Point Beach Nuclear Plant, Units 1 and 2
Dockets 50-266 and 50-301
Renewed License Nos. DPR-24 and DPR-27

License Amendment Request 277, Revision to Staff Augmentation Times in the
Point Beach Nuclear Plant Emergency Plan

LICENSE AMENDMENT REQUEST 277

FIGURE 5-3
TECHNICAL SUPPORT CENTER (TSC) AND OPERATIONS SUPPORT CENTER (OSC)

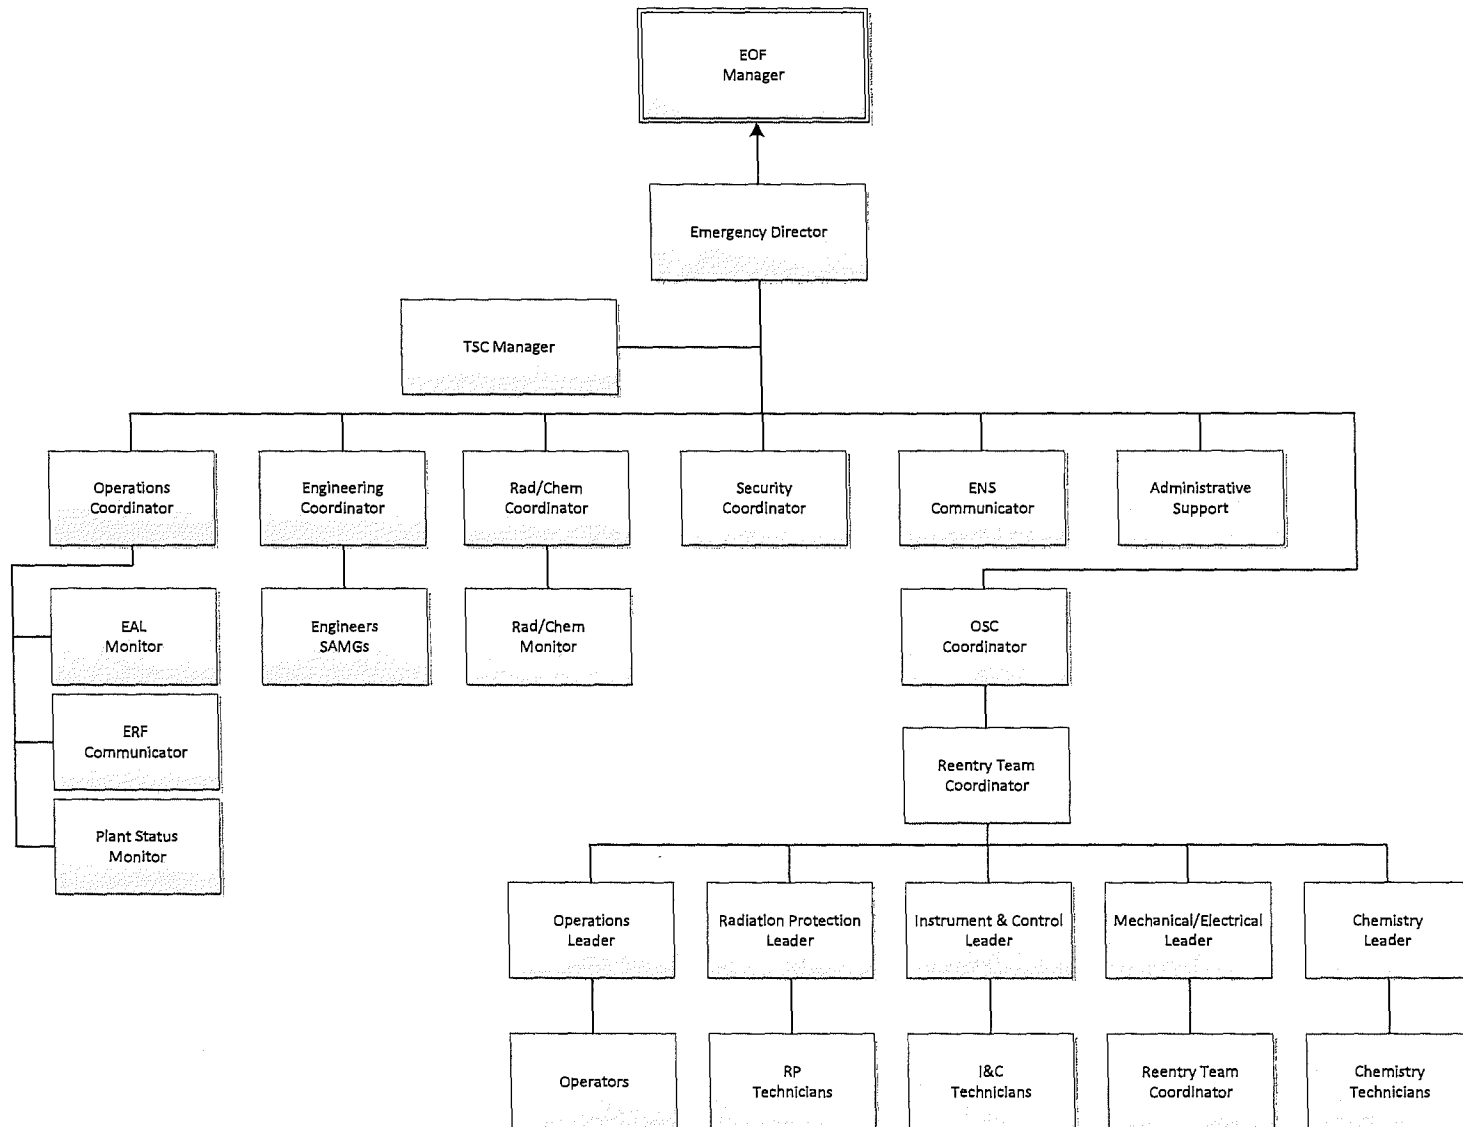
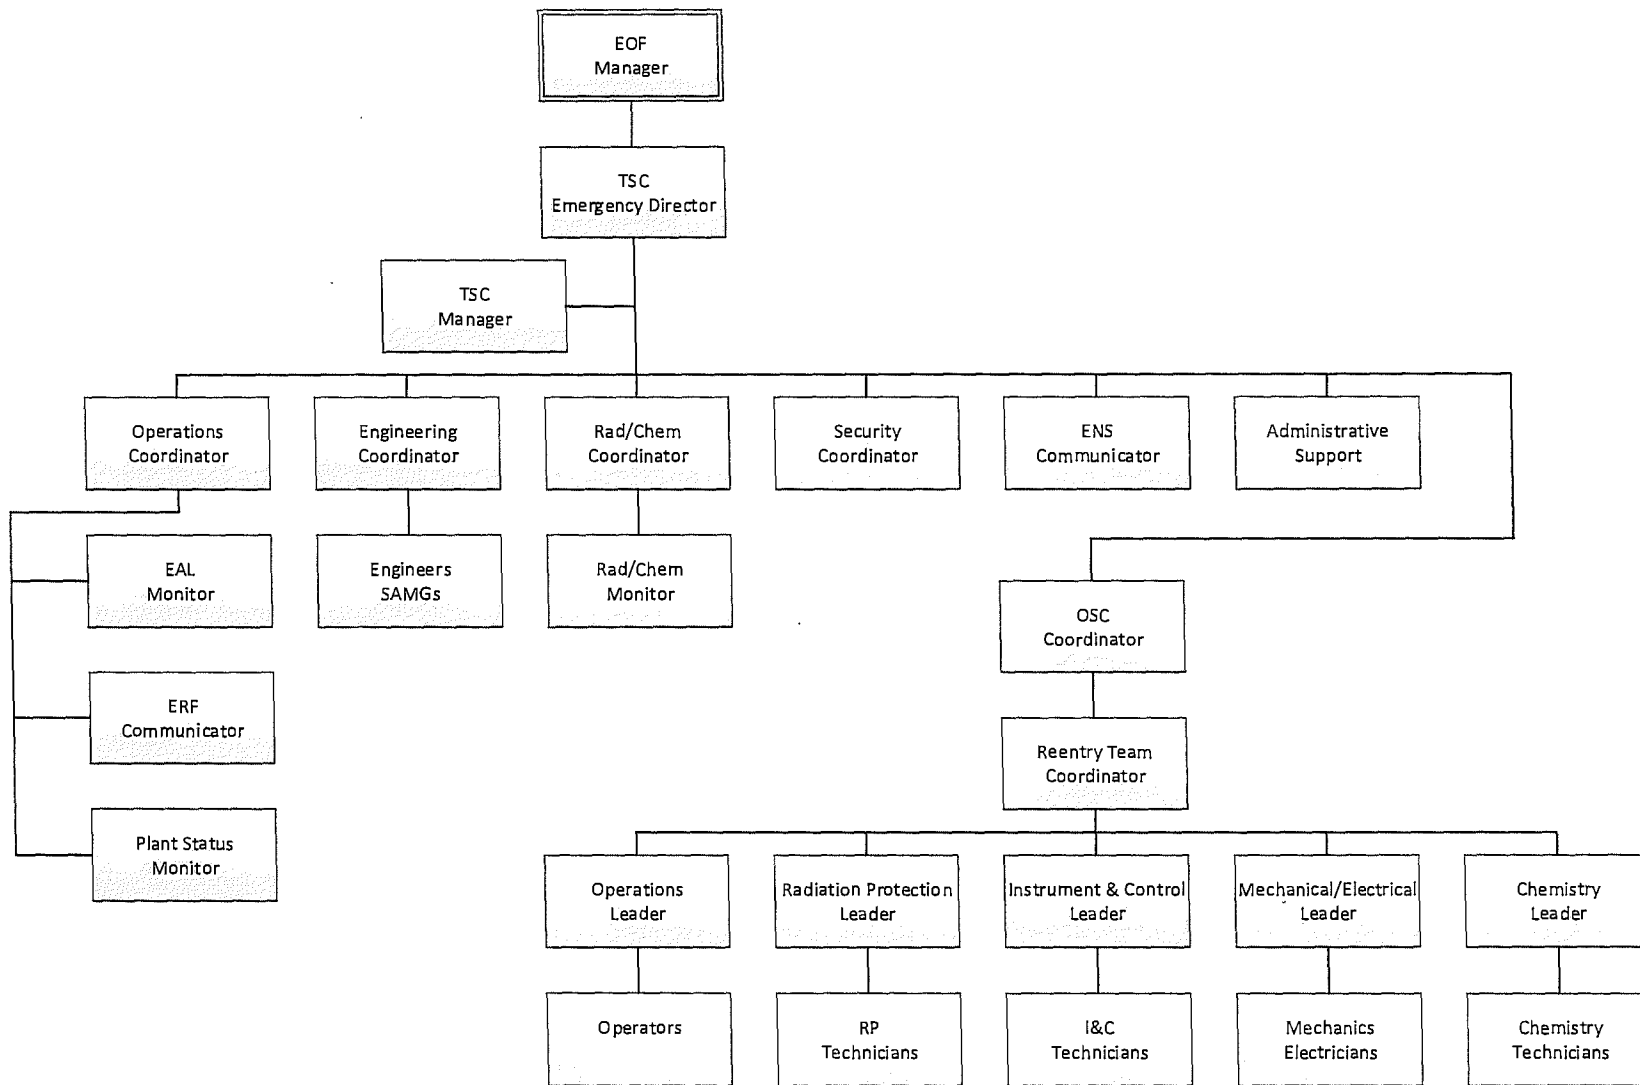
- o. EP 5.0, "Organizational Control of Emergencies," Figure 5-3, "Technical Support Center (TSC) and Operations Support Center (OSC)," has been revised to reflect the addition of the Emergency Director position and the EAL Monitor to the TSC organization.

FIGURE 5-4
EMERGENCY OPERATIONS FACILITY (EOF) AND OFFSITE RADIATION PROTECTION FACILITY (OSRPF)

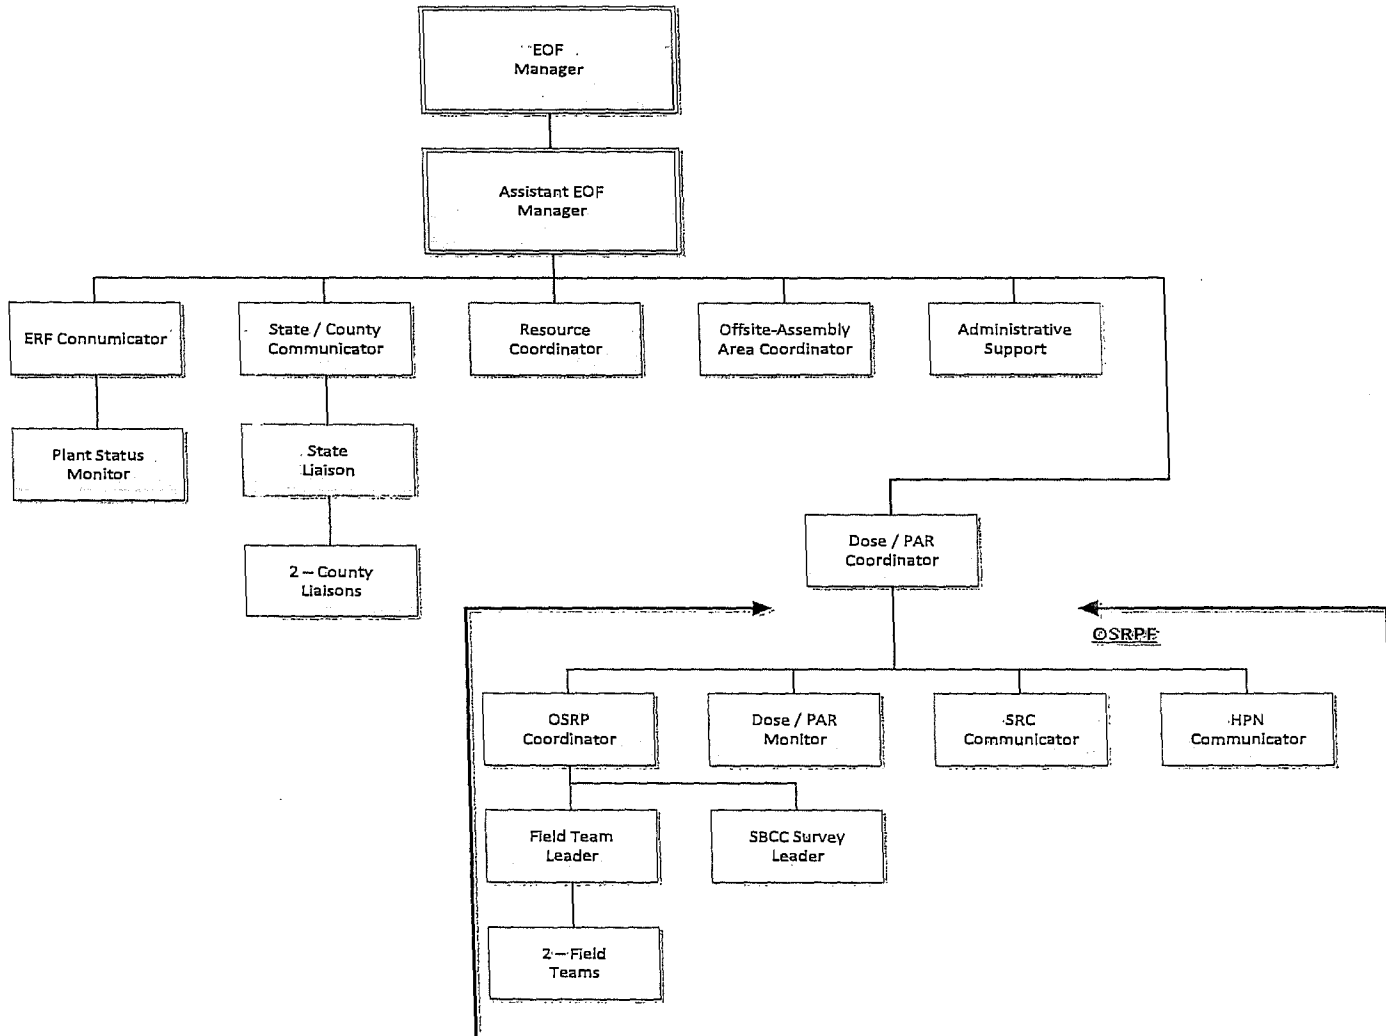
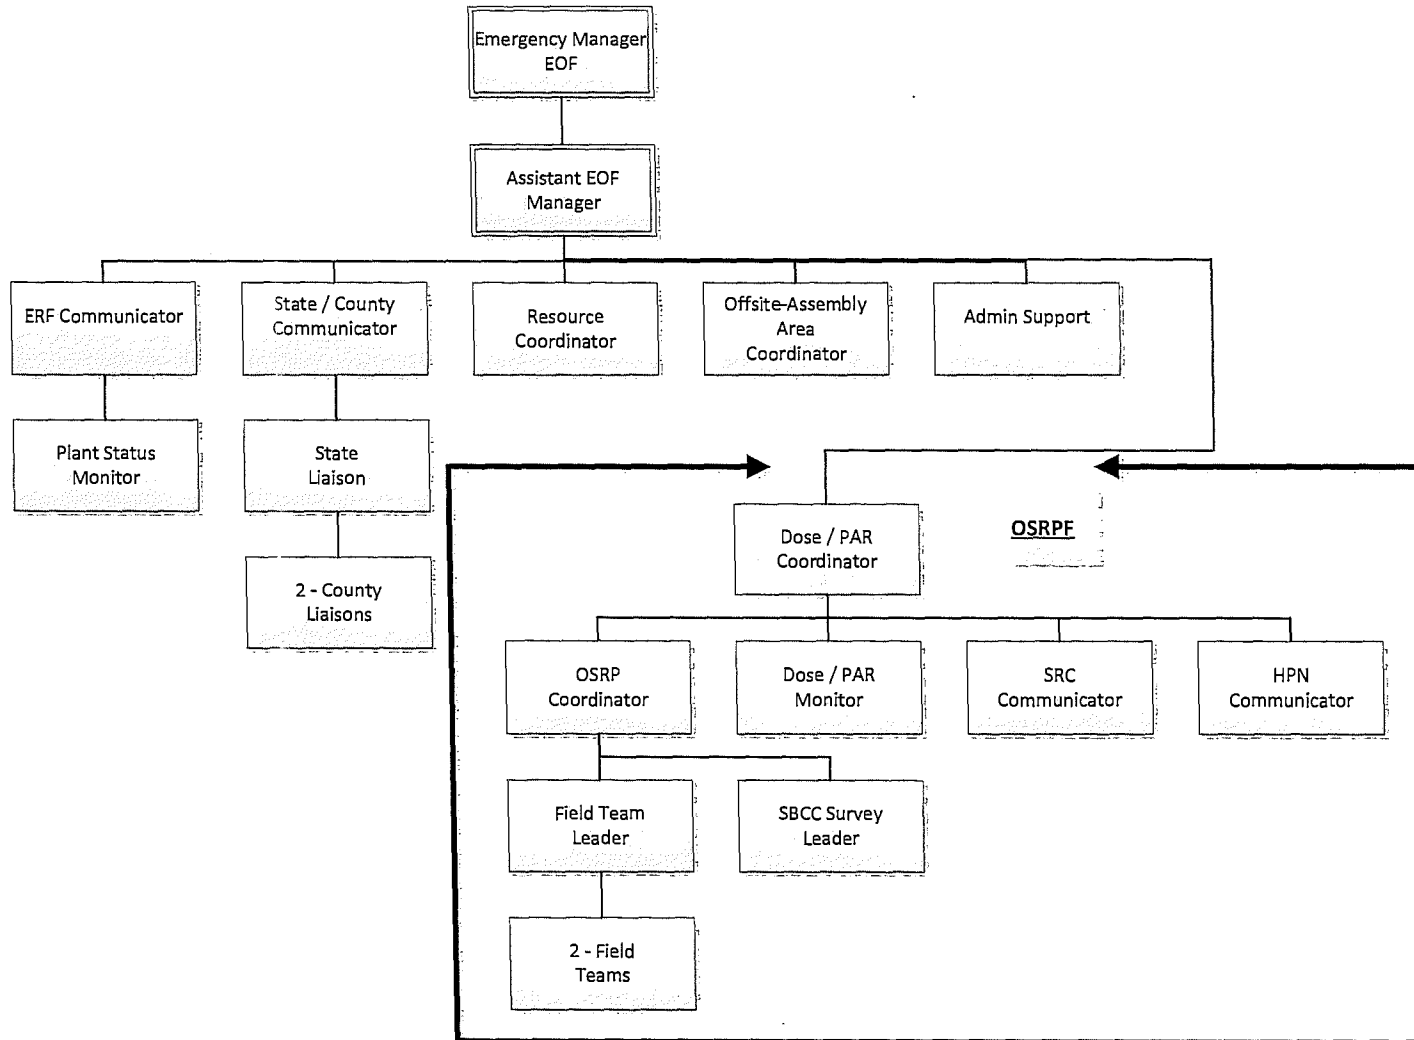
- p. EP 5.0, "Organizational Control of Emergencies," Figure 5-4, "Emergency Operations Facility (EOF) and Offsite Radiation Protection Facility (OSRPF)," has been revised to reflect:

- The title change from Emergency Director to Emergency Manager EOF
 - The addition of the Assistant EOF Manager position
 - Removal of the EAL Monitor position from the EOF in accordance with the change cited in Figure 5-3.
